69-75 PICCADILLY, MANCHESTER BACK PICCADILLY TIMBER SASH REPLACEMENT - CENTRE MULLION DETAILS

DATE - 26.10.23
SCALE - FULL SIZE @ A3

B

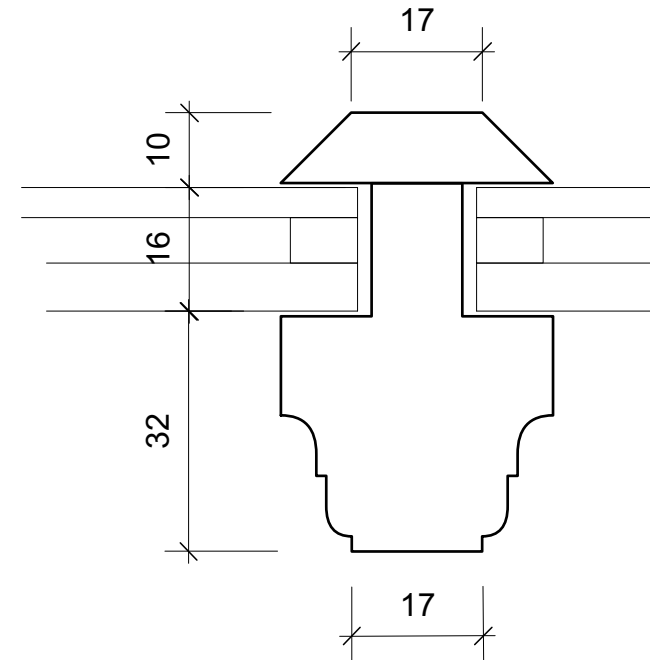
GROUND FLOOR
PRESUMED ORIGINAL
Existing box frames confirm
50mm deep original sashes
not 58mm as first floor

D

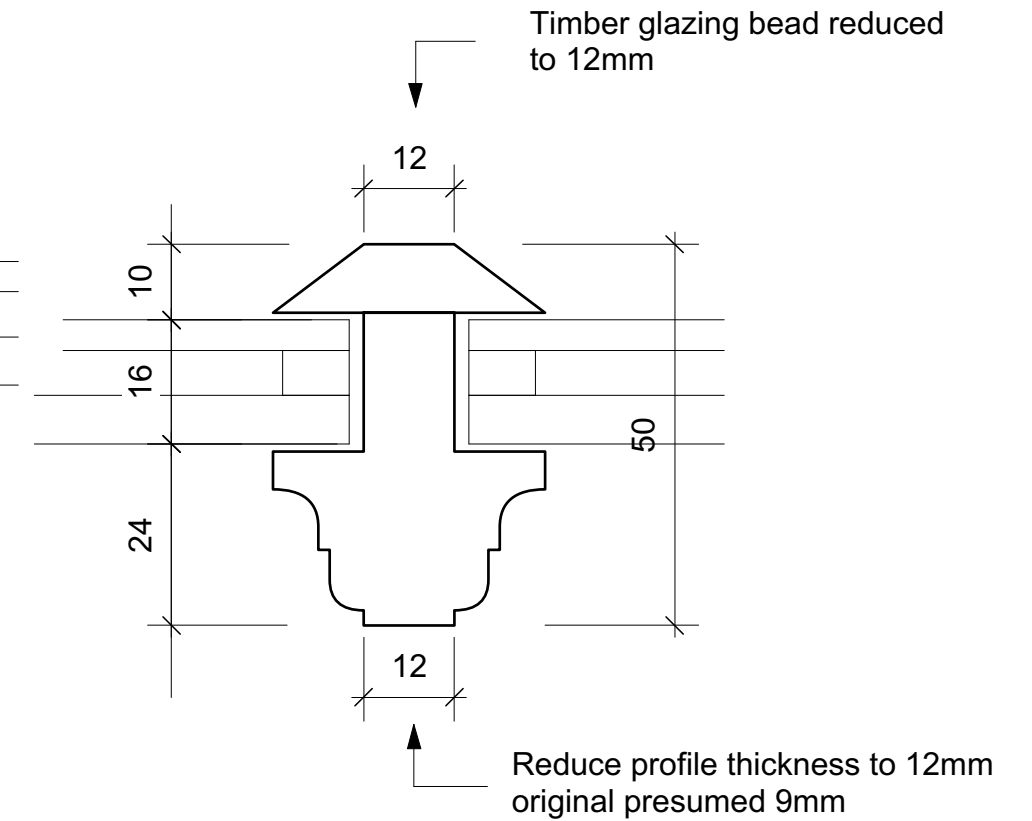
PROPOSAL 26.10.23
Responding to AL/PM email comments
